RFQ CCC-039 Instructional Building #1 - ADDENDUM 1

1. Pre-Bid RFC-001 through 004 and RFC-006 through 011 with Answers

2. Changes to the Specifications

3. Changes to the Drawings

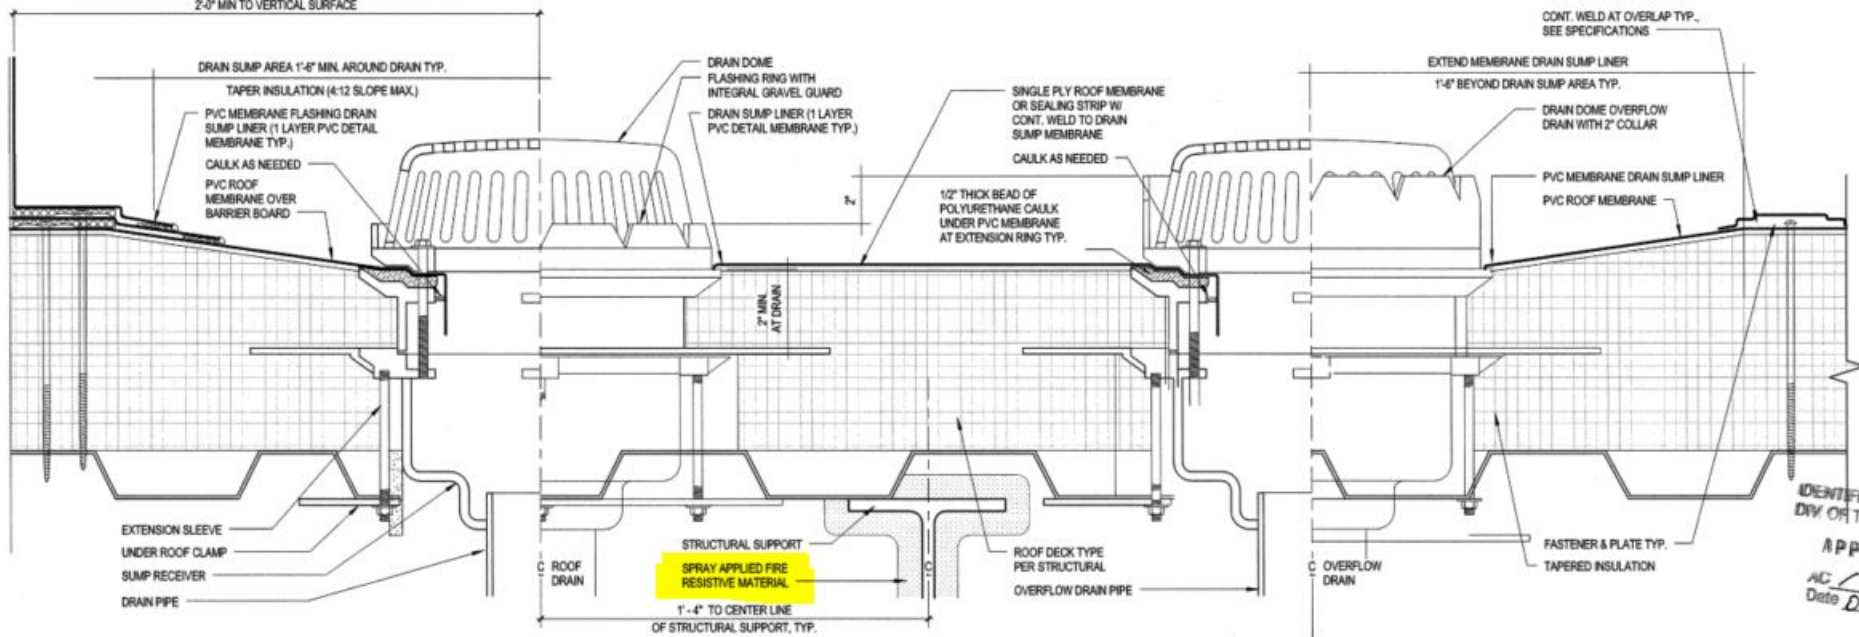
Per Architectural drawing A8.03 and A10.01, fireproofing material is being called out.

Please provide the specification for the fireproofing material.

Fireproofing of the structural steel is not required per "Fire Resistive Construction - Type II-B" of the Code Analysis on sheet CP1.01. Contractor to ignore fireproofing illustrated around structural steel and/or metal decking indicated in the document details.

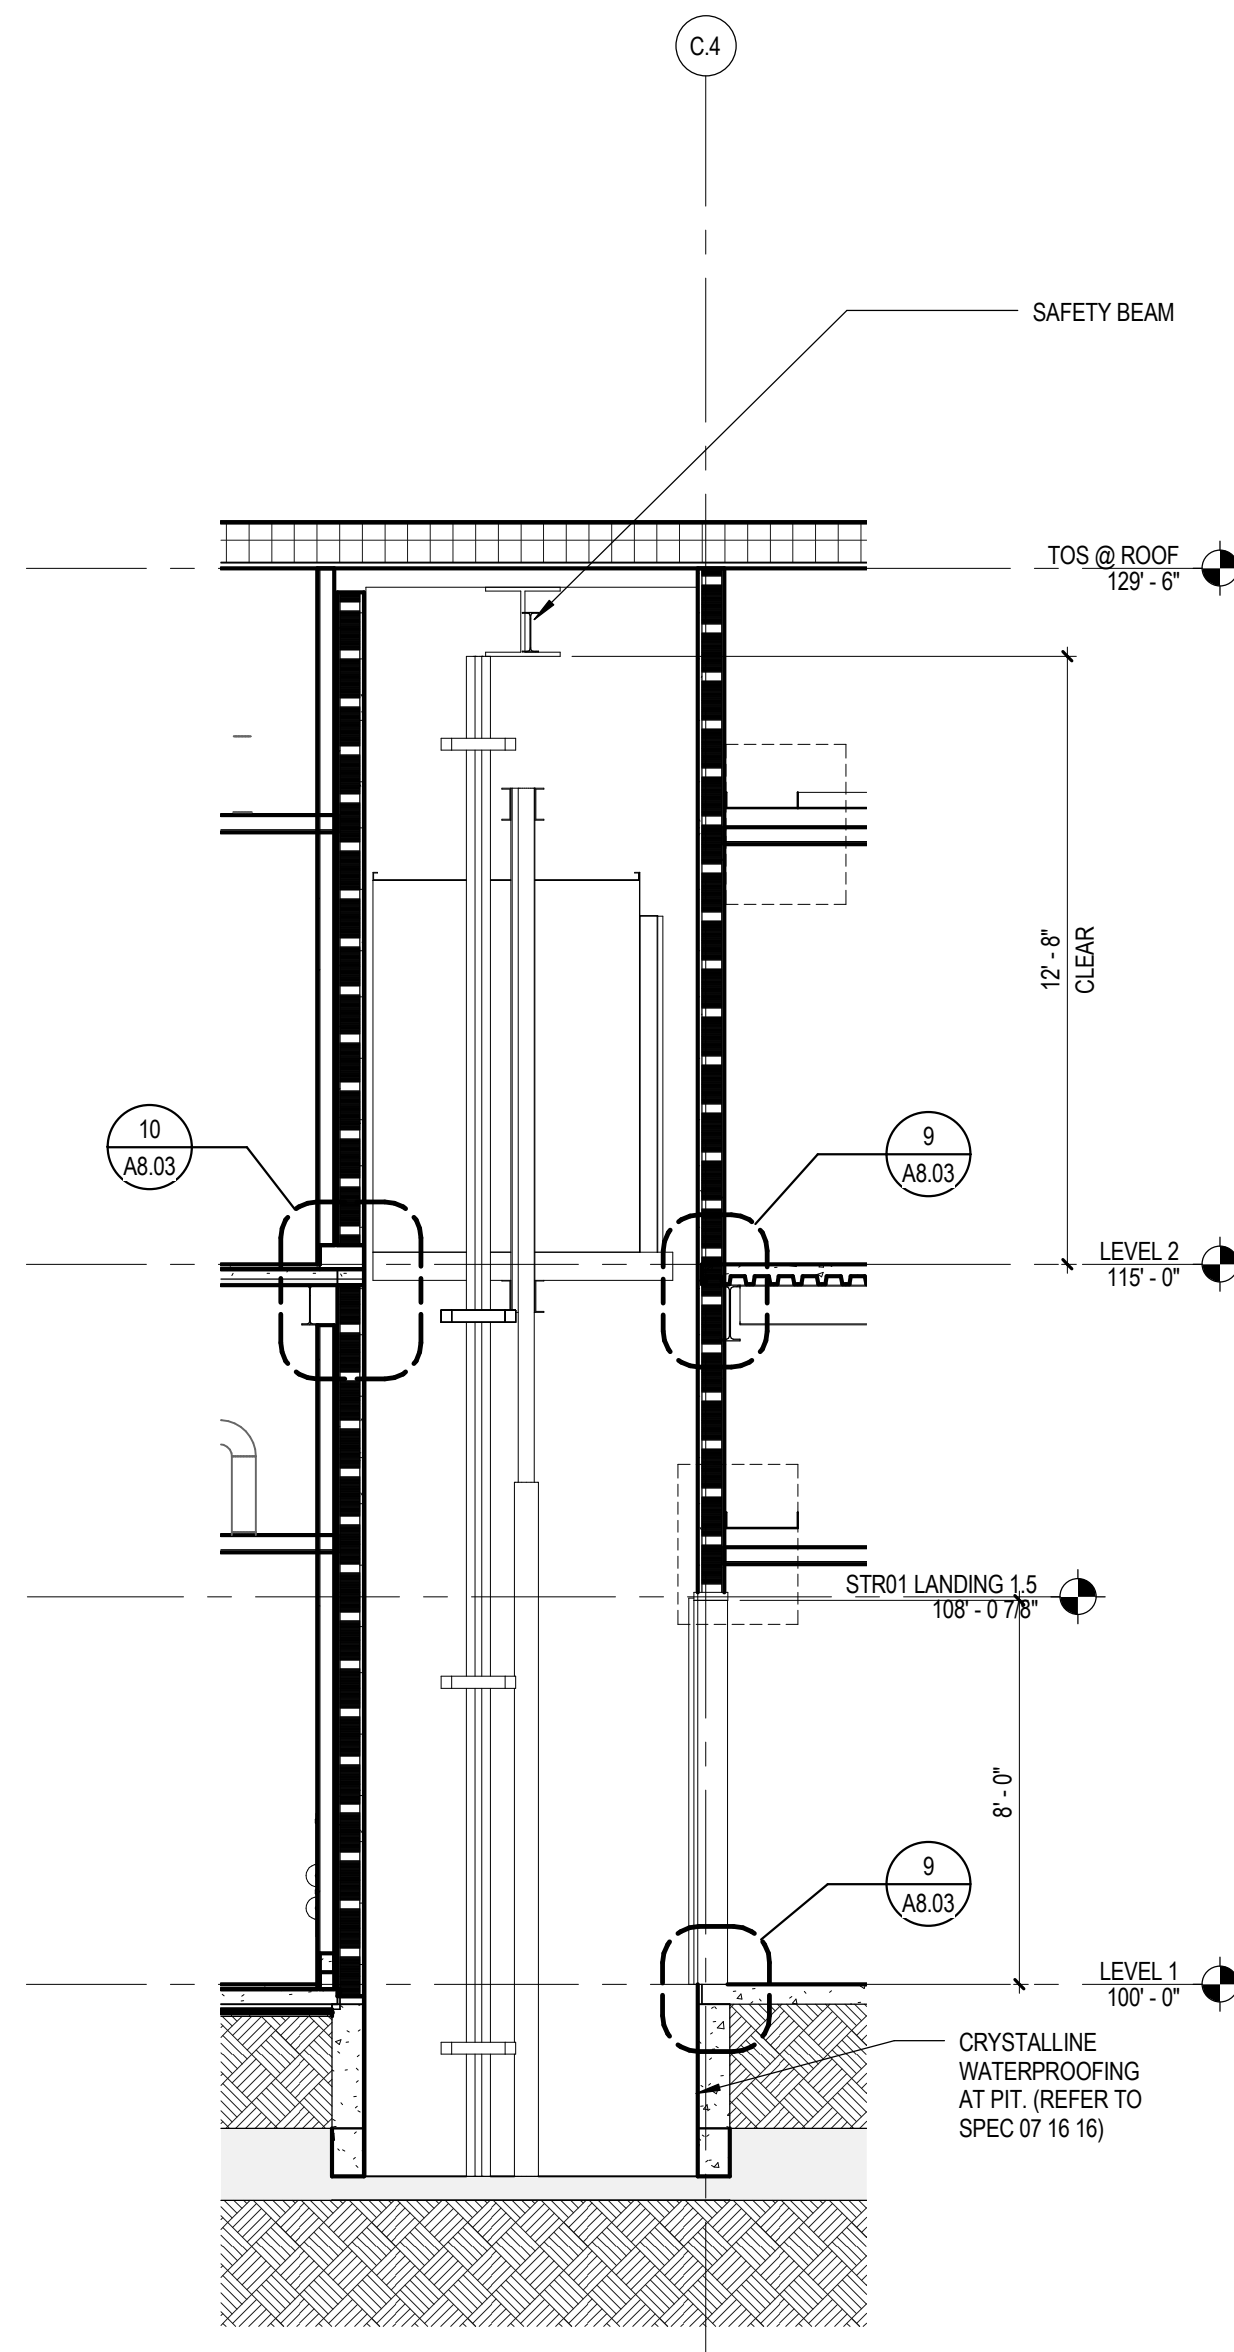
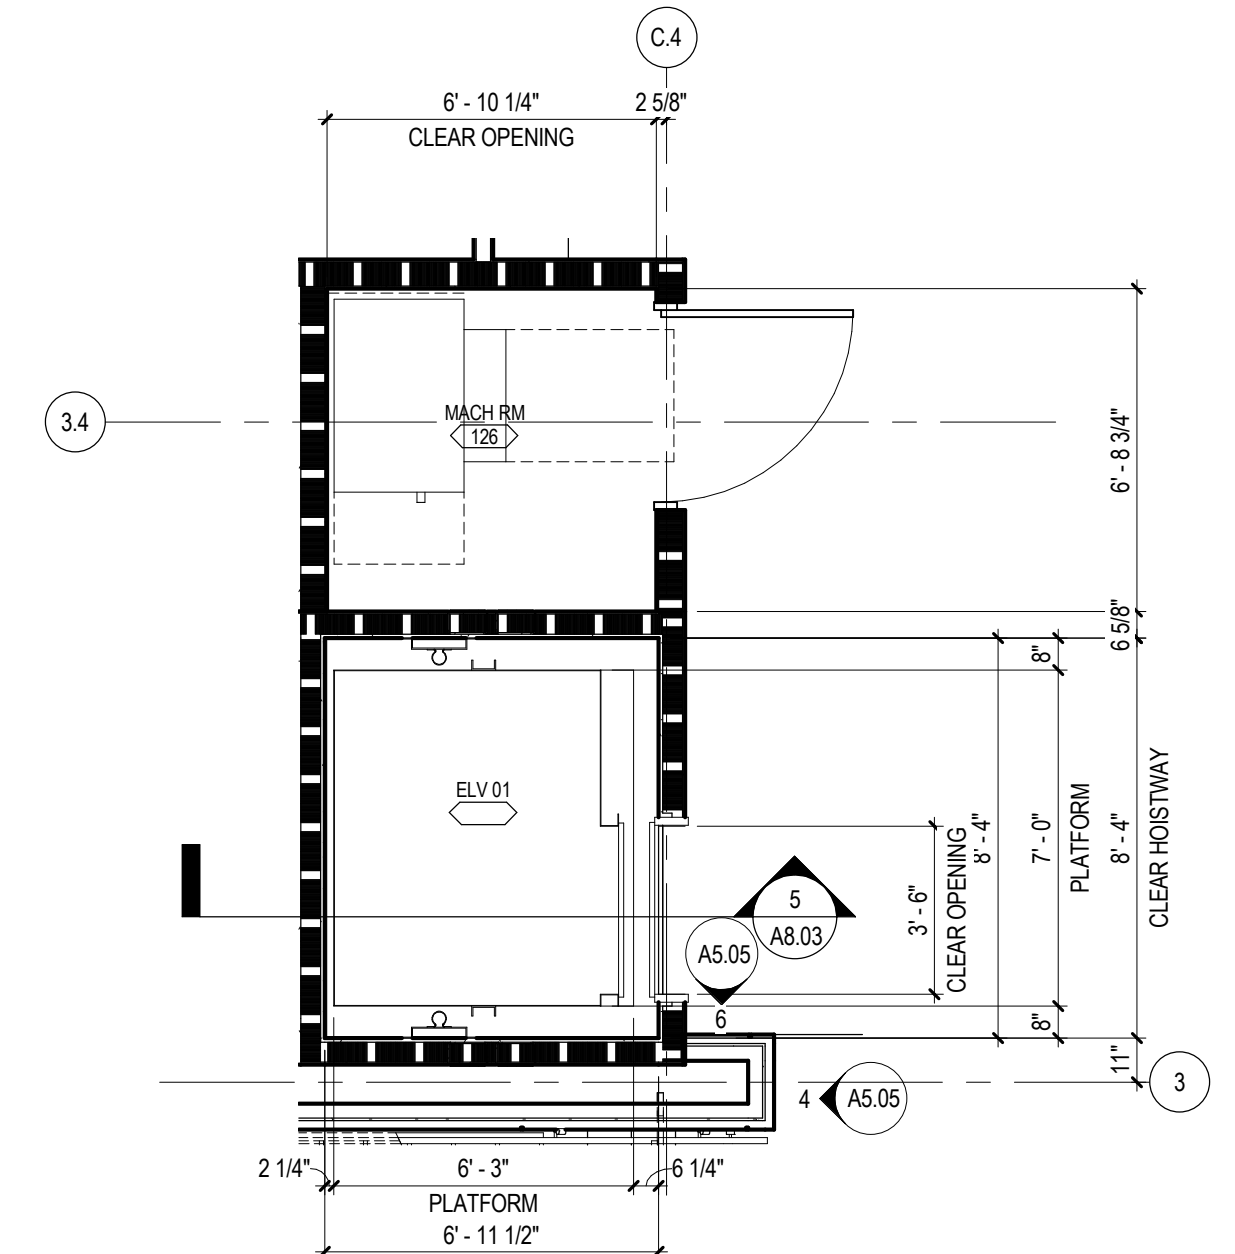
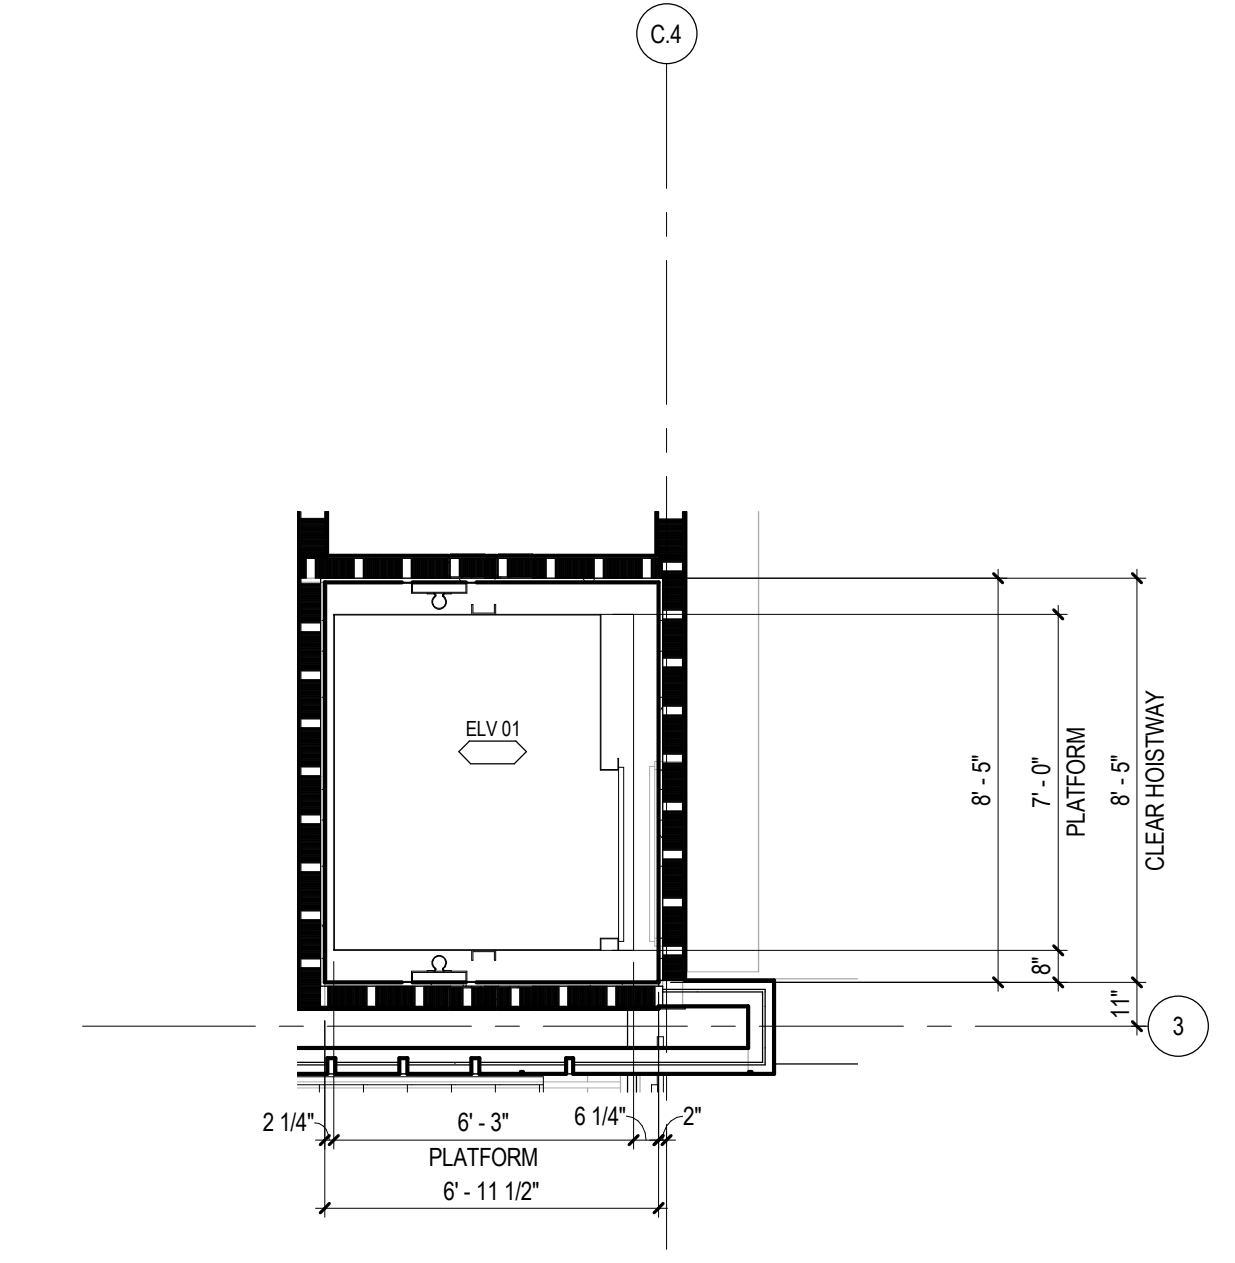
Sheet A8.03 – ELEVATOR - PLANS, SECTIONS & DETAILS

- A. Revised Detail 10/A8.03 – 1-HR SHAFT EDGE OF SLAB: Concrete curb adjusted, Detail callout 3/A9.01 added, keynotes added.

A8.07
75-15238-00

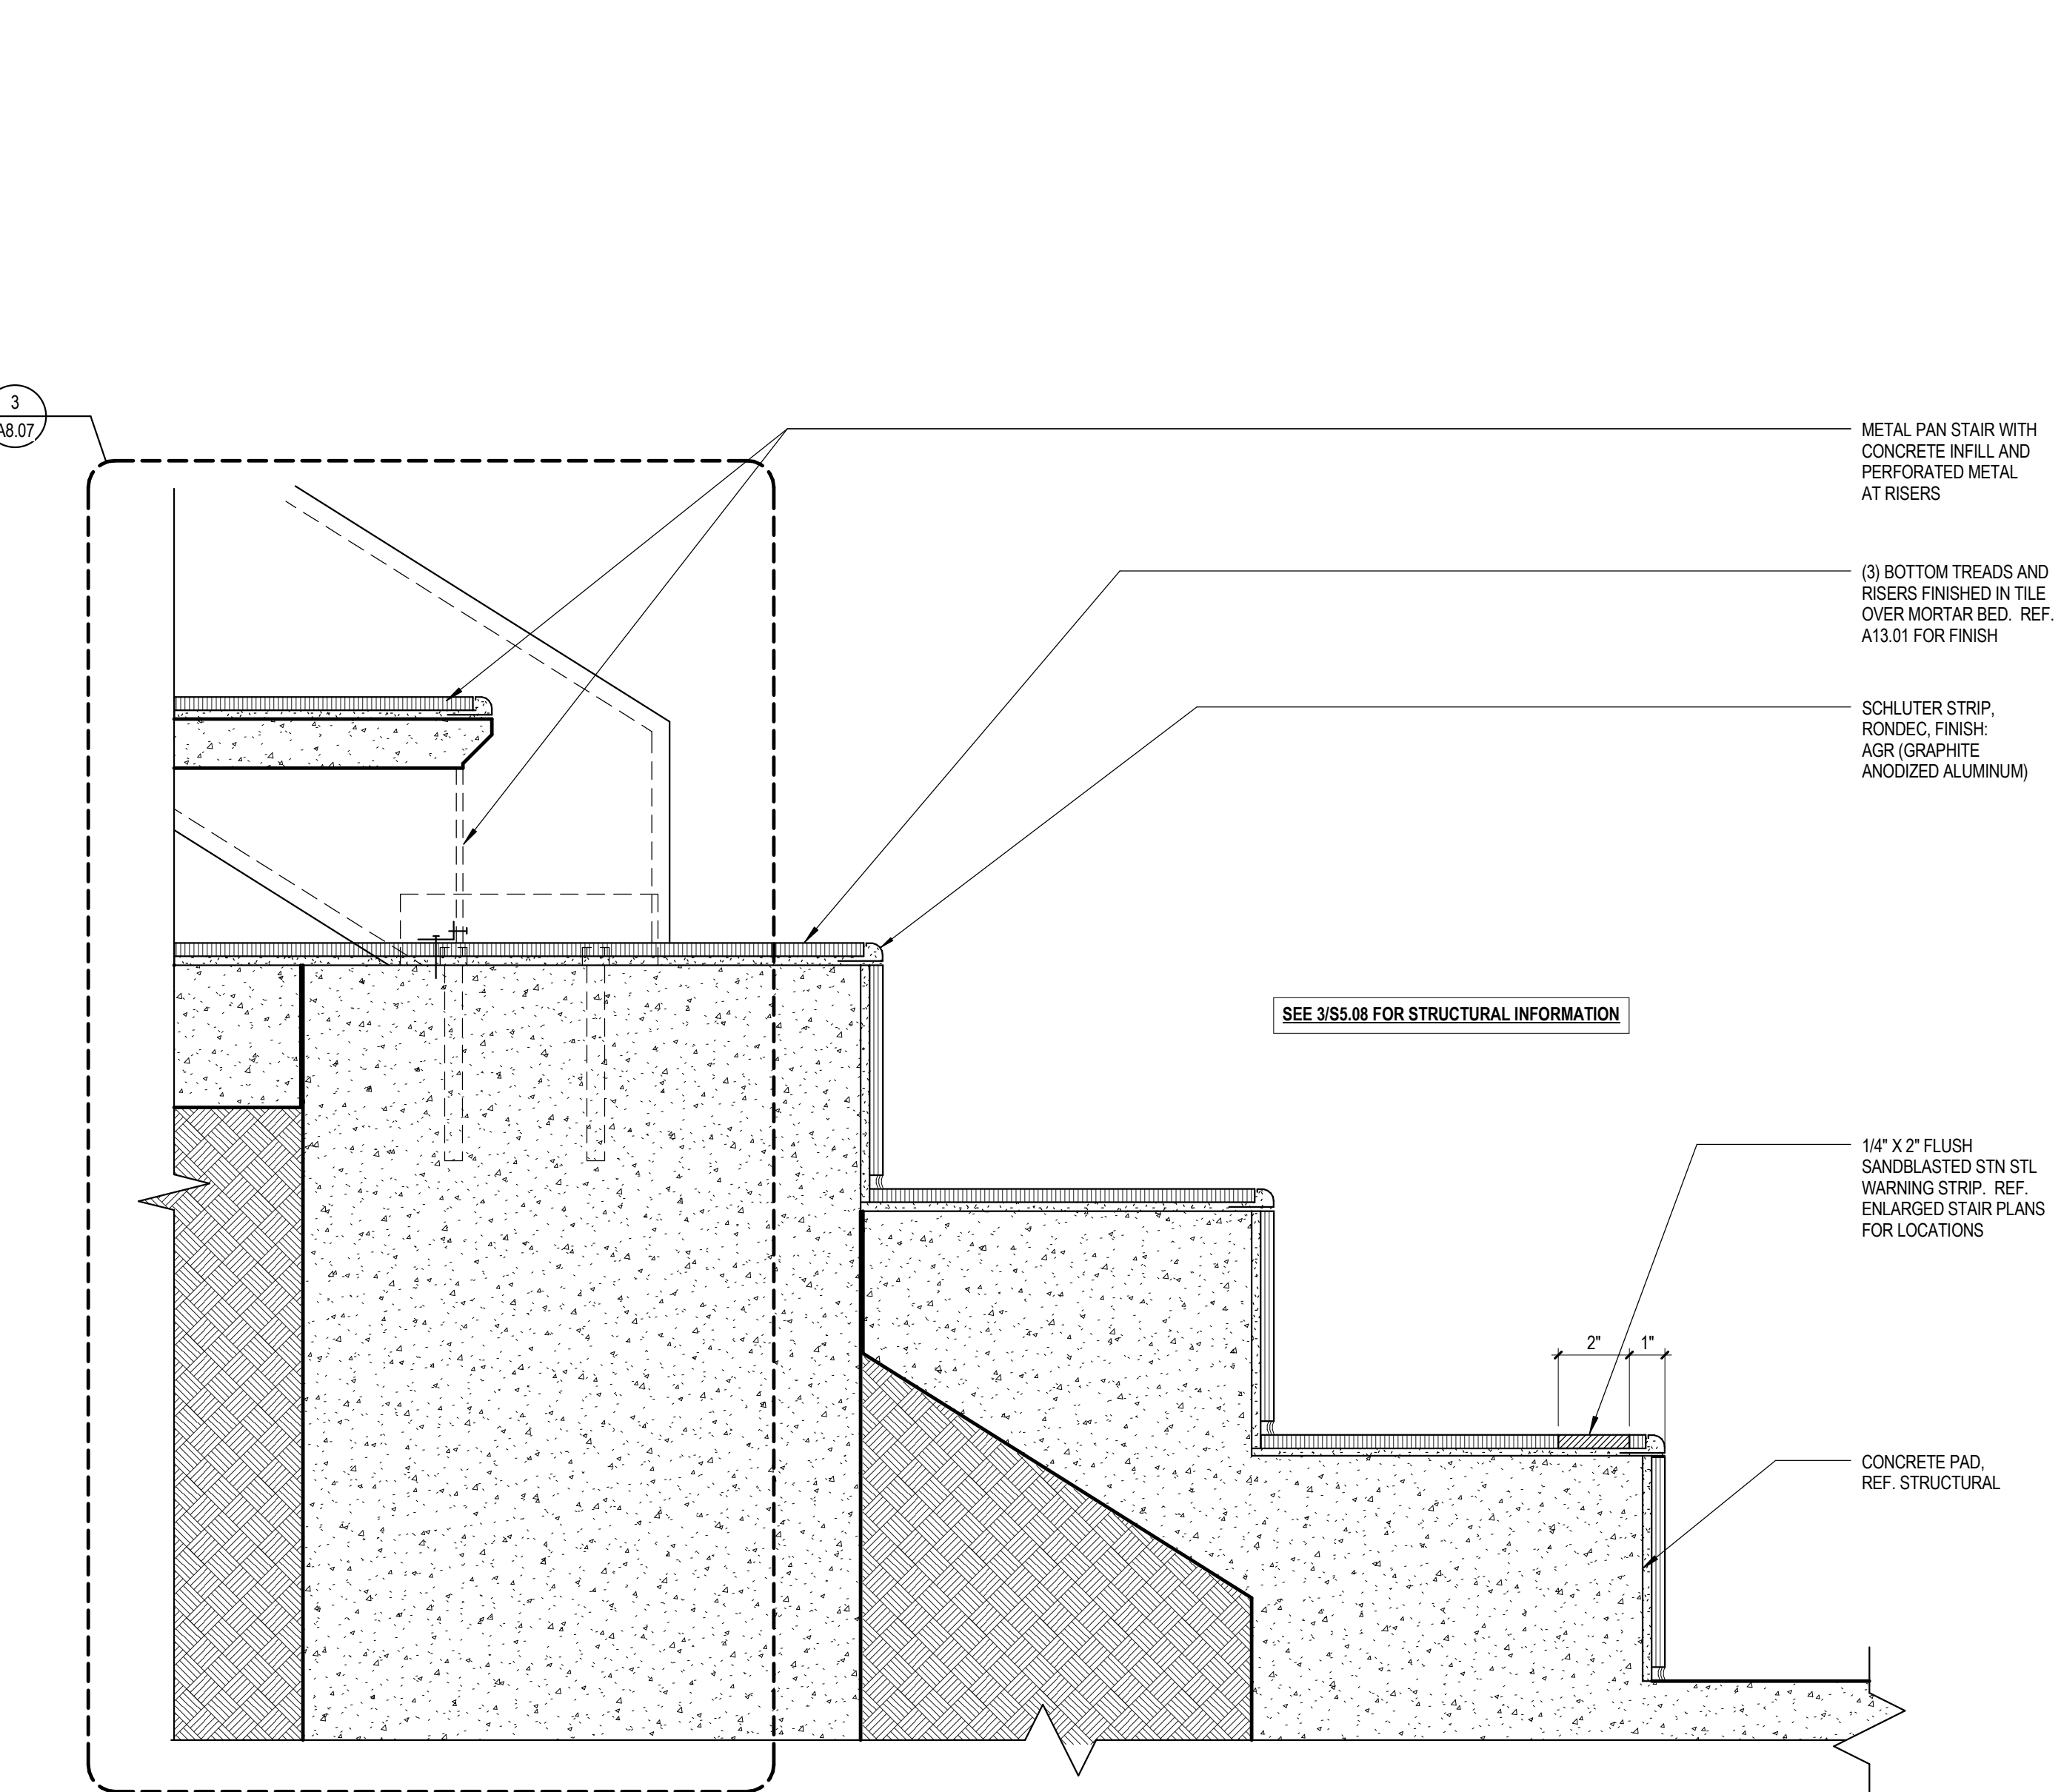
Sheet A8.07 – STAIR DETAILS

- B. Revised Detail 8/A8.07 – SECURITY FENCE SILL: Added weld symbols to attachment of 3"x3" HSS to HSS Tube and Cap Plate to HSS.
